ARKANSAS POWER & LIGHT COMPANY
POST OFFICE BOX 551 LITTLE ROCK, ARKANSAS 72203 (501) 371-4000

September 10, 1979

Subject: Arkansas Nuclear One-Unit 1
Docket No. 50-313
License No. DPR-51
Degraded Grid Voltage
(File: 1510)

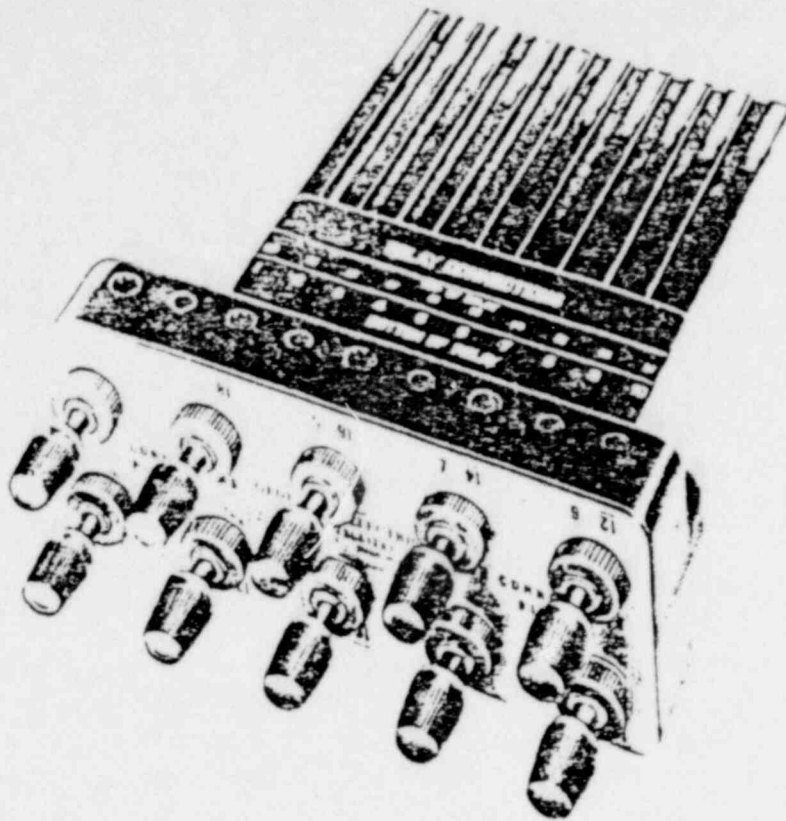
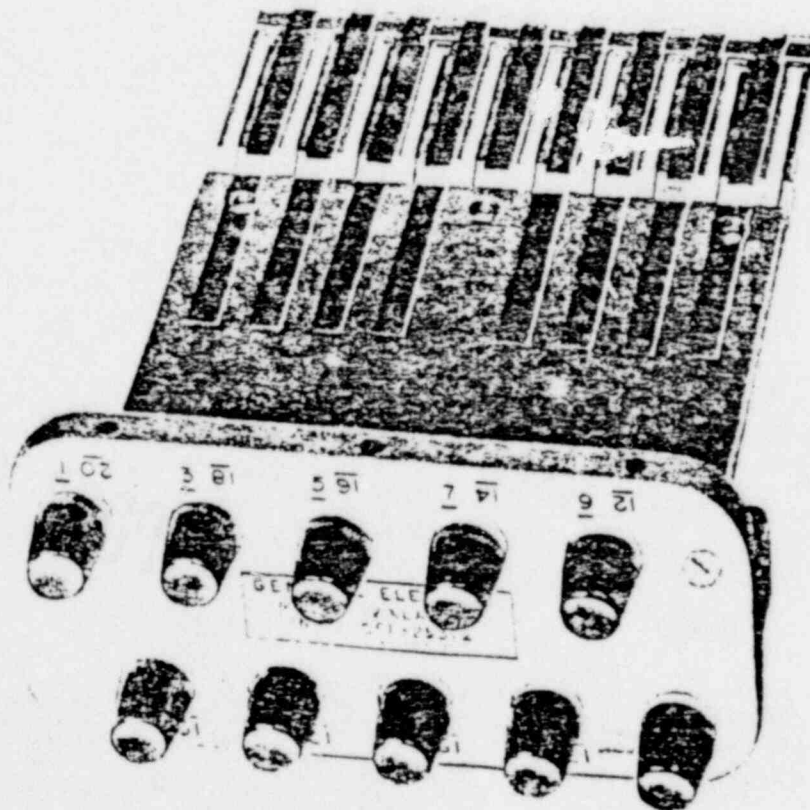
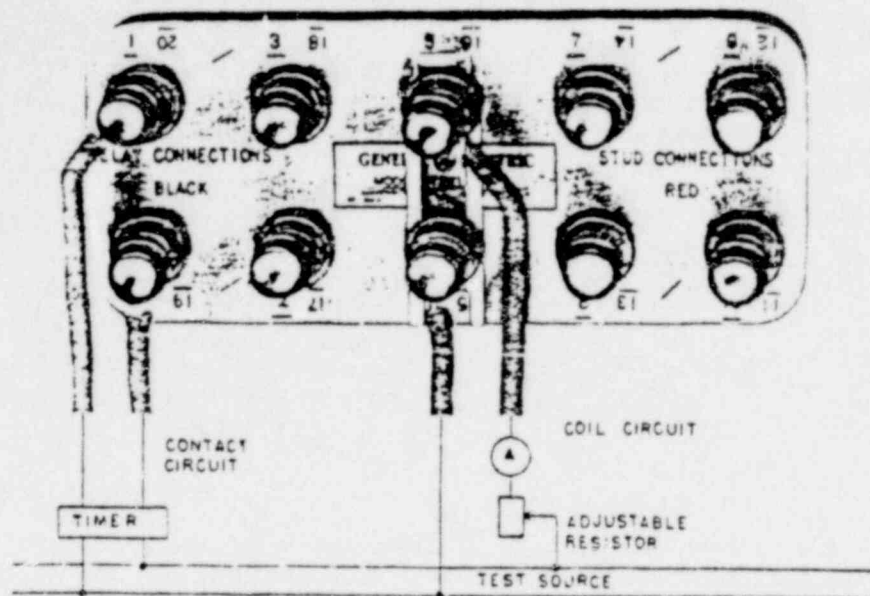
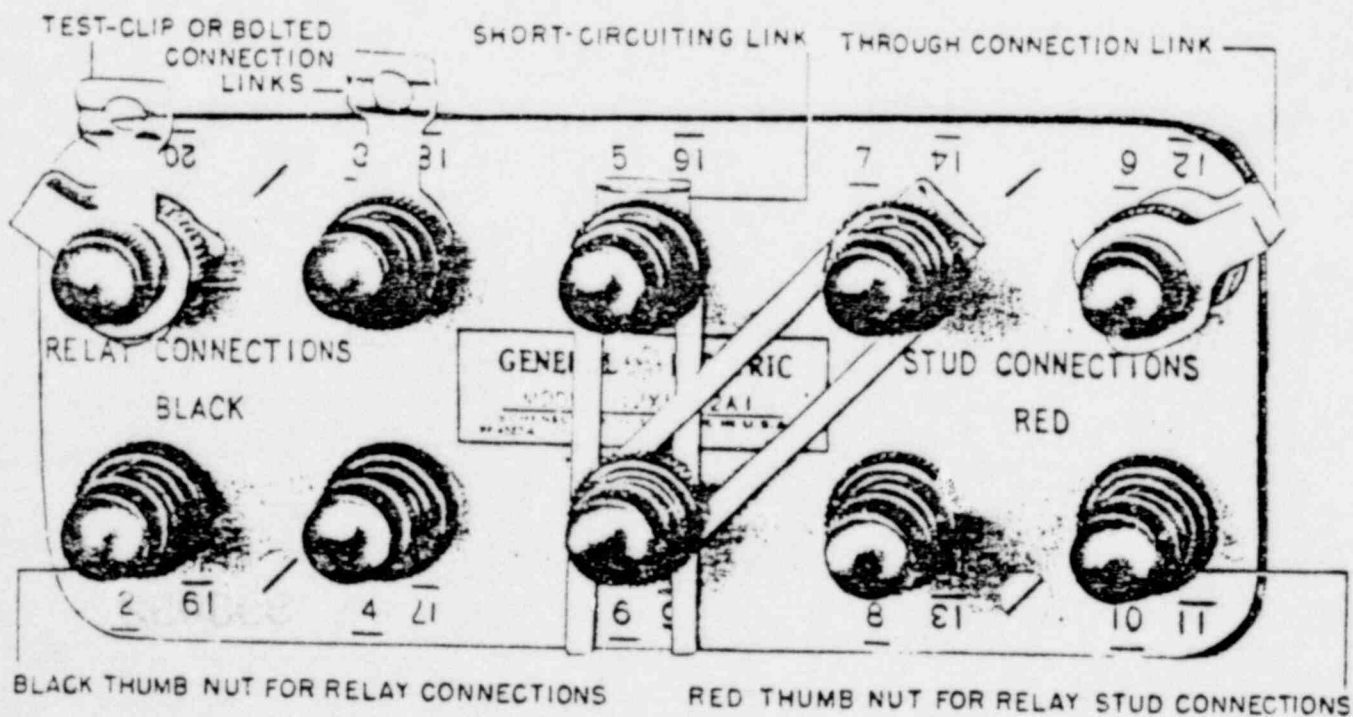
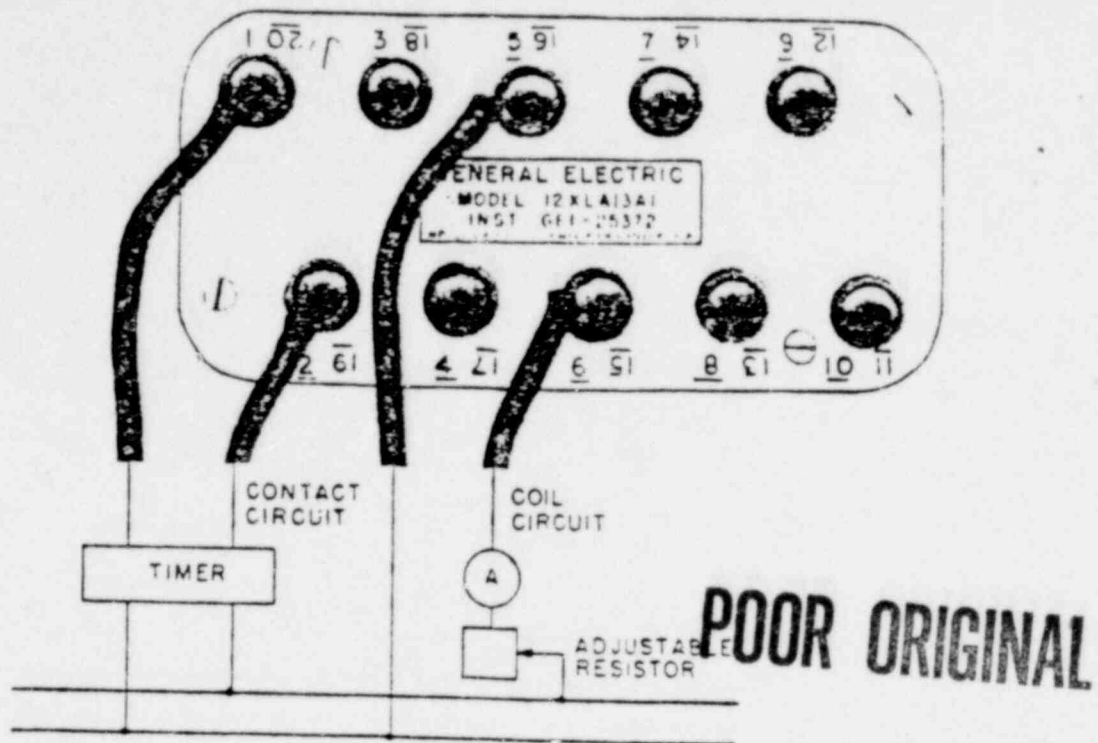
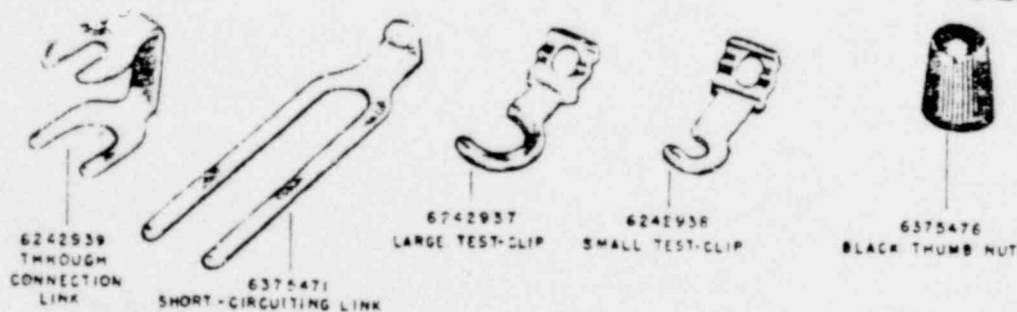
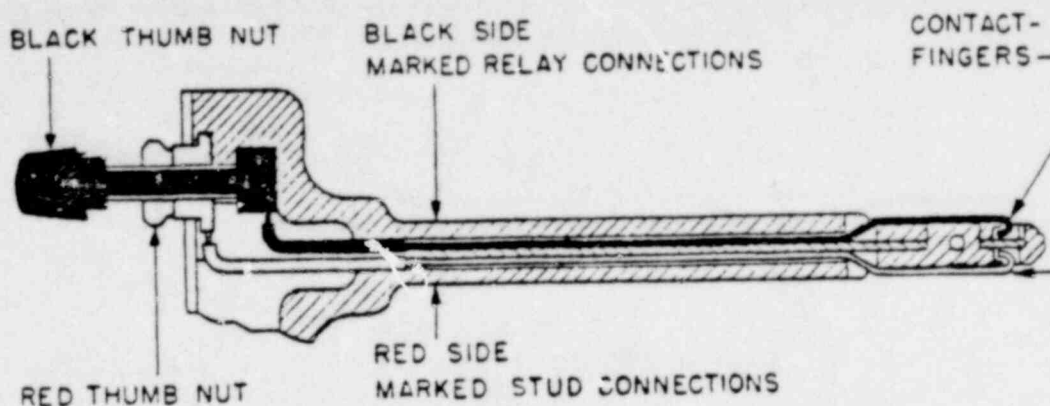
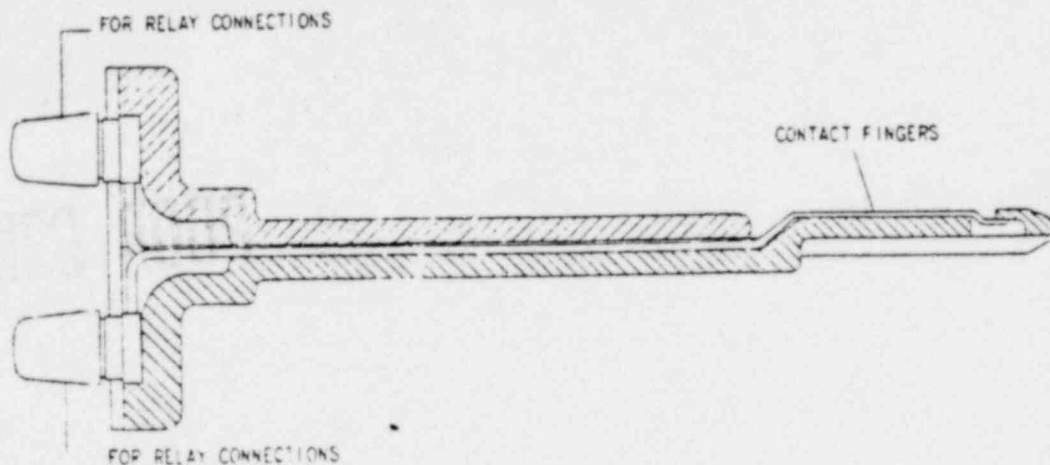
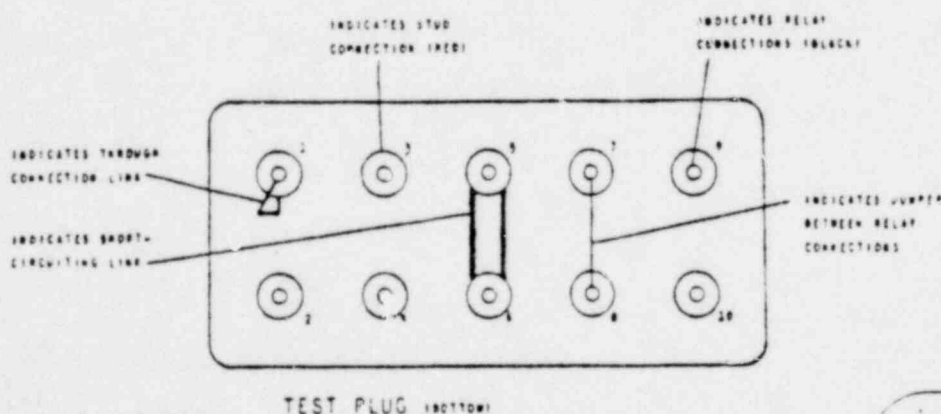
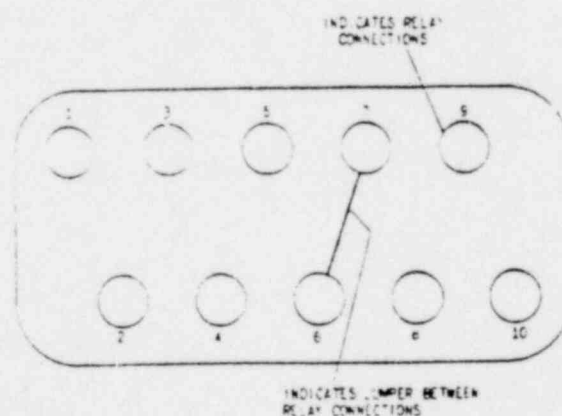
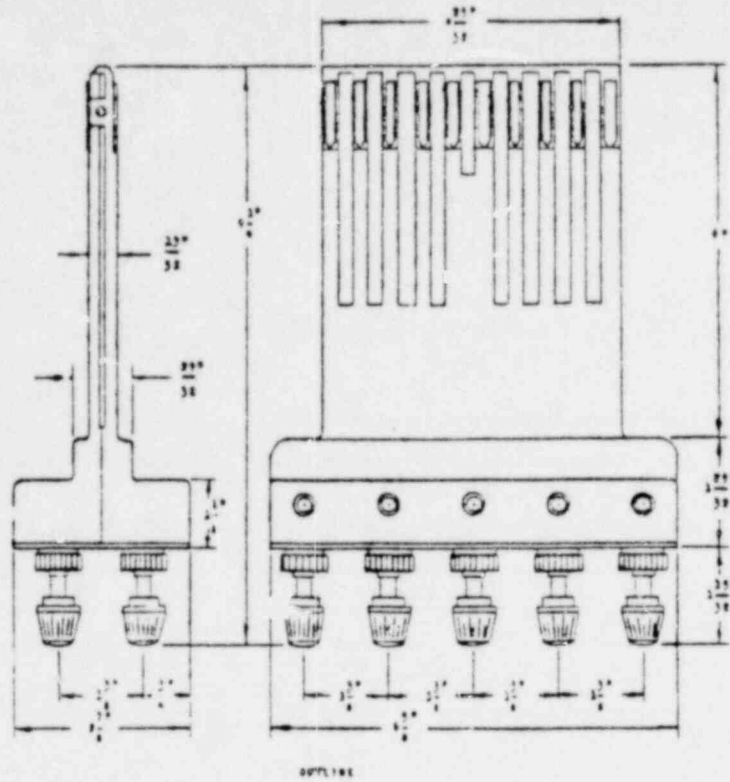
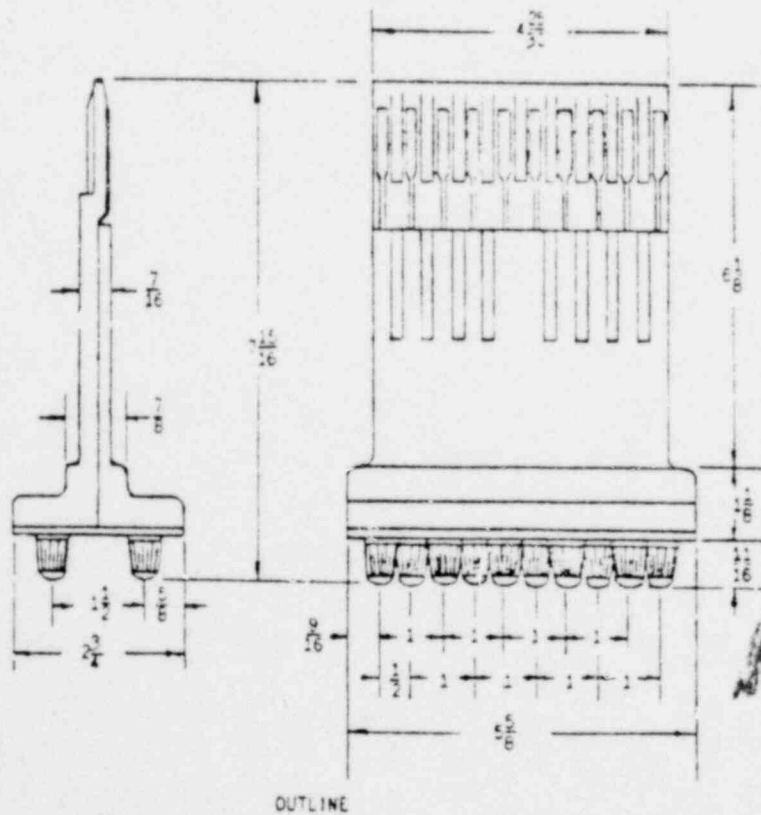
The proposed undervoltage relays will have test plug capability. Describe the test plugs, their function, and their effect on the relay. How is the test performed and specifically what is the function which is tested? Provide a schematic which illustrates the function of the test plug on the relay.

Attached is instruction manual G.E. H-1768A showing the connecting plugs. A description of the test plug is shown by the attached publication GEI-25372. When the connecting plug is removed and a test plug is inserted in its place, all relay points are accessed, both the relay side and the source side, since each side is brought to a separate terminal on the test plug.

Since this relay is an undervoltage relay with contact closure output set to close at a specific set point, the relay contact closure can be verified at the set point without execution of the desired final action.
